## **AMENDMENTS TO THE FIGURES**

The following corrections to the drawings have been made. Red-lined versions of the drawings and replacement pages are included herewith. Applicant respectfully requests acceptance of the amended drawings.

**FIG. 5**

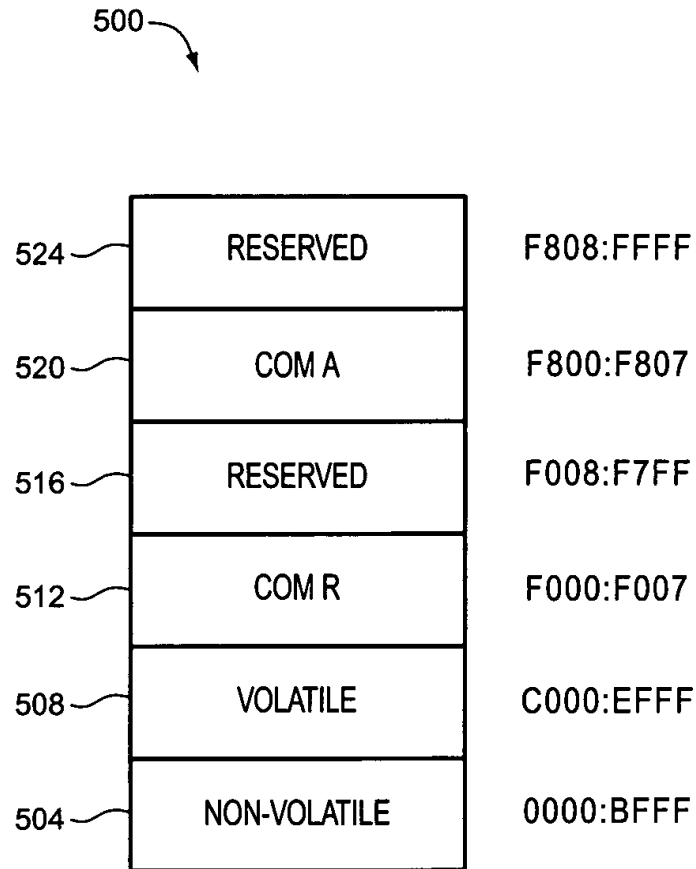
**Figure 5** – The address “F000-F00F” for COM R (element 512) has been corrected to read “F000:F007”.

FIG. 8

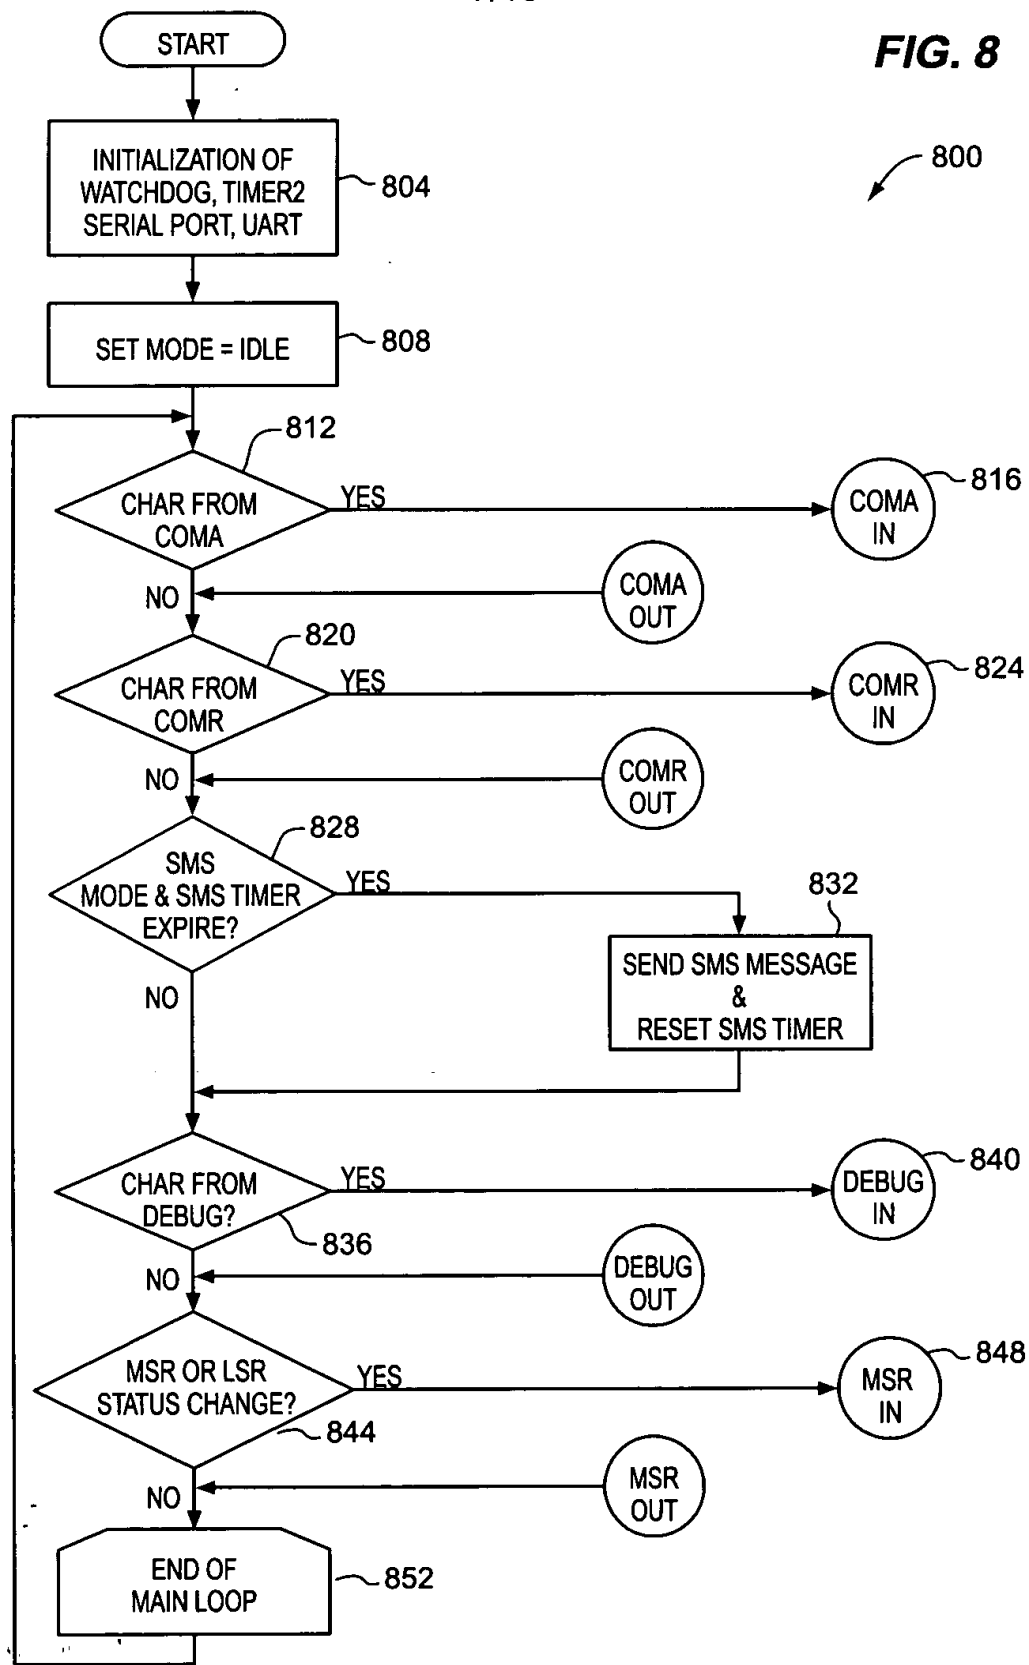
**Figure 8** – The missing element numbers 844 and 852 have been added. Element 848 has been corrected to read “MSR IN”, rather than “DEBUG IN”.

FIG. 9

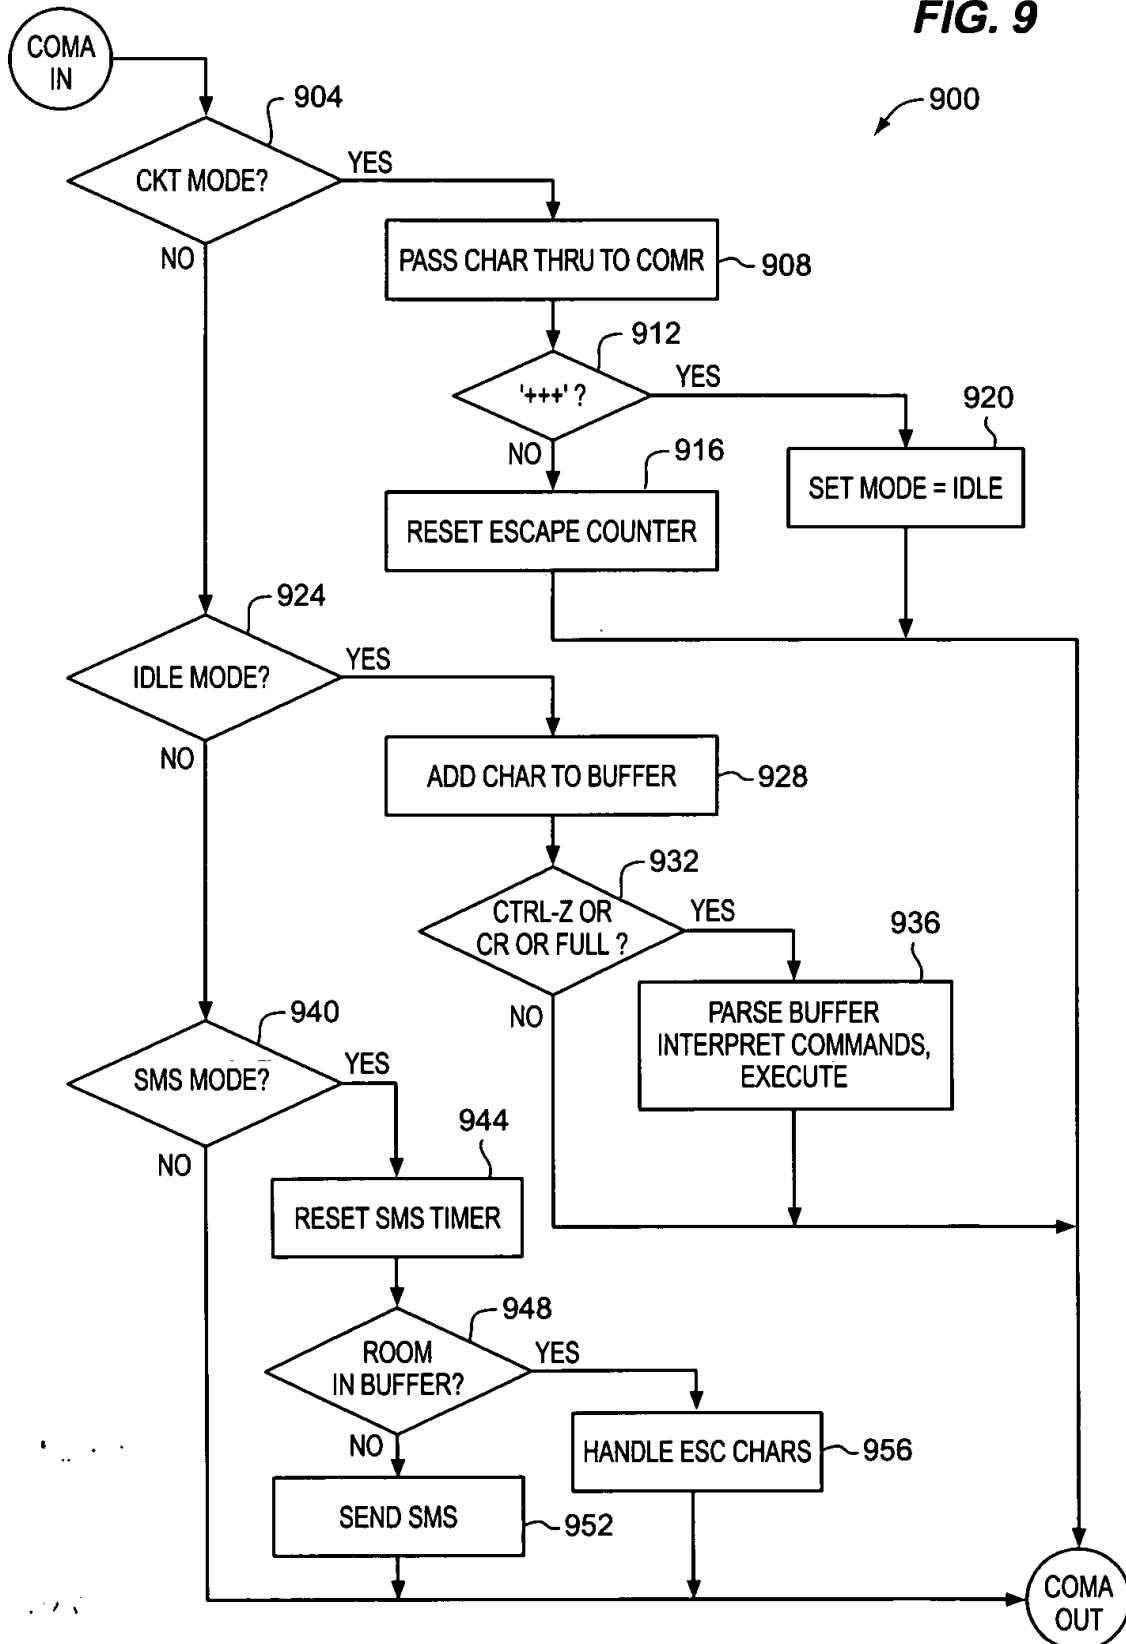
**Figure 9** – The missing element number 916 has been added.

**FIG. 11**

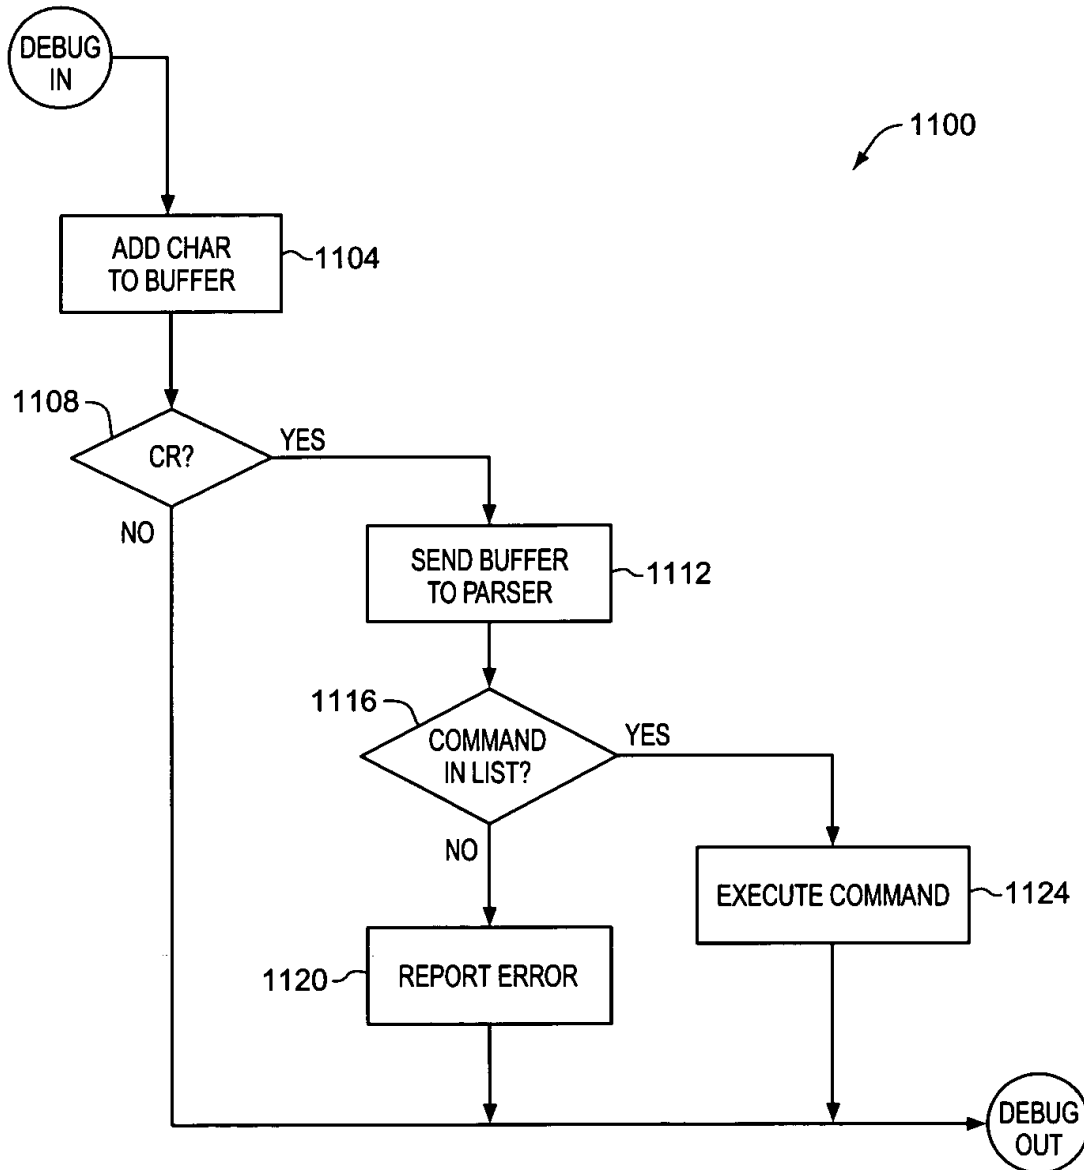
**Figure 11** – Element 1120 has been corrected to read “REPORT ERROR”, rather than “RECORD ERROR”.

**FIG. 13C**

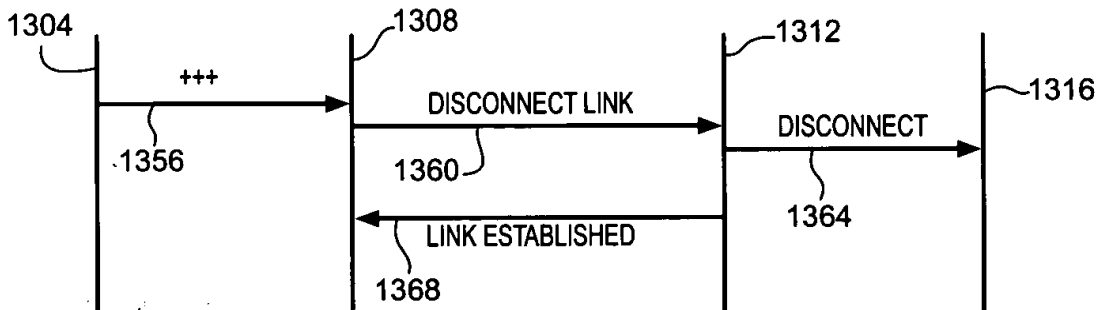
**Figure 13C** – The designation for element 1356 has been corrected to be “+++”, rather than “+++ATH”.

FIG. 15c

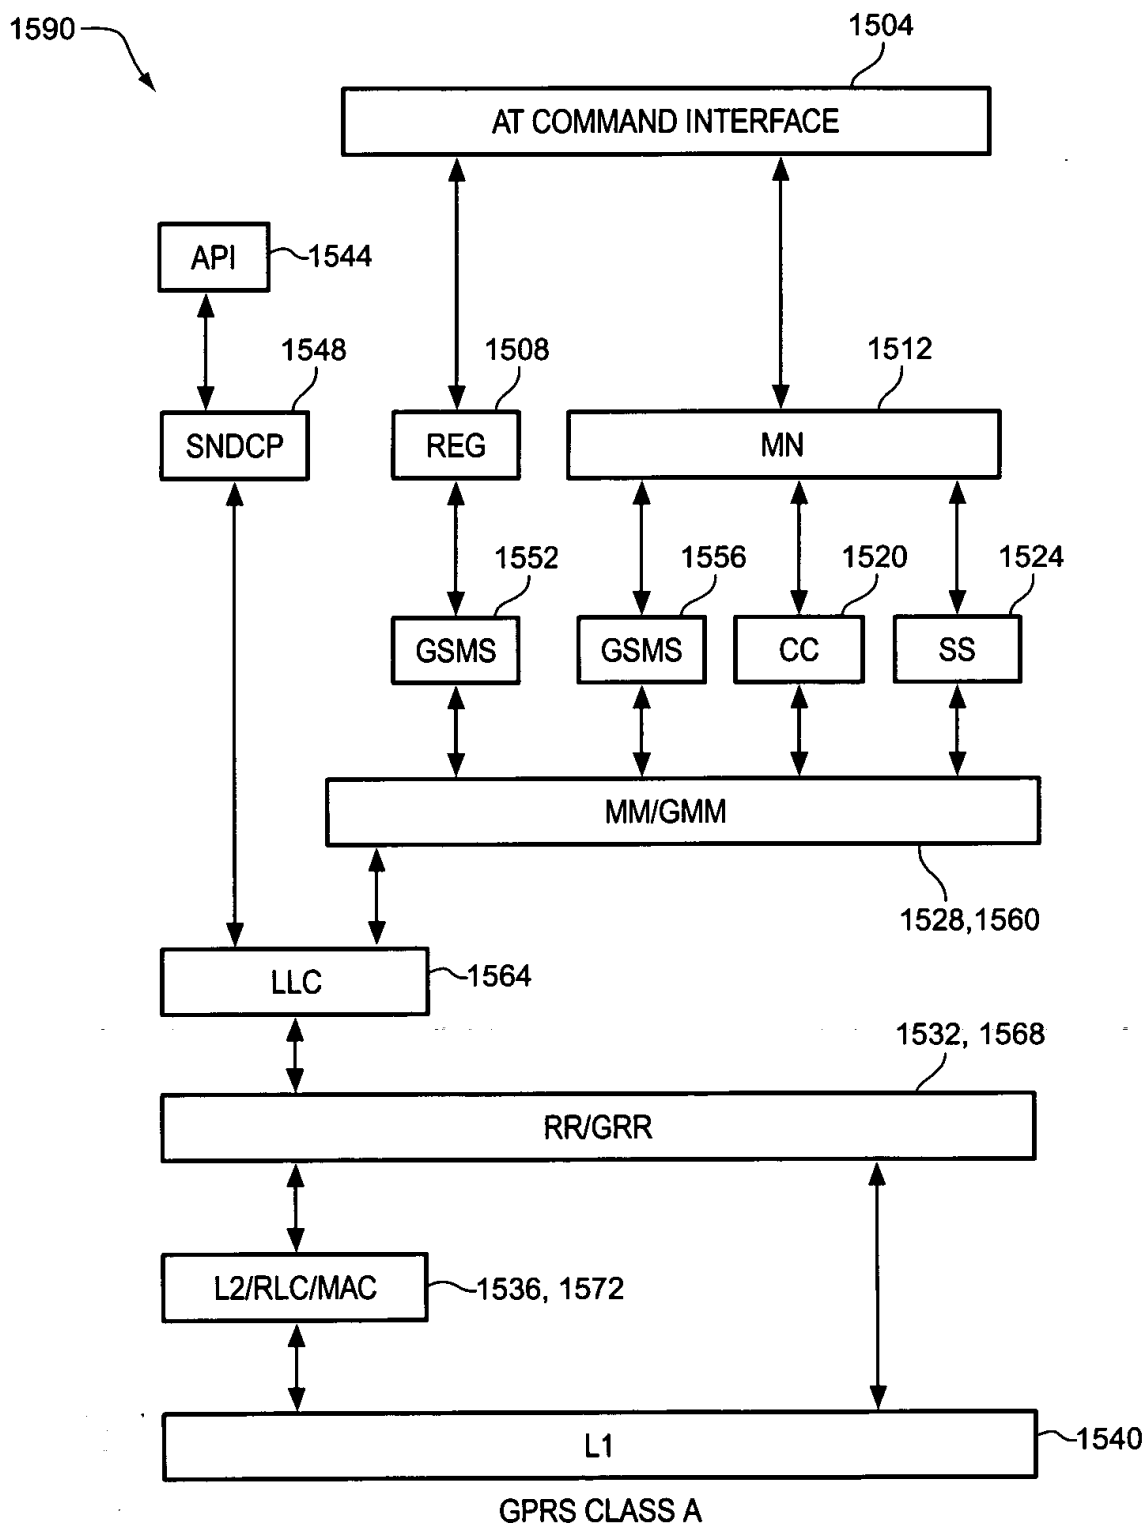
**Figure 15C** – The element designated as “RR/GRR” has been corrected to have element number 1568, rather than 1588.
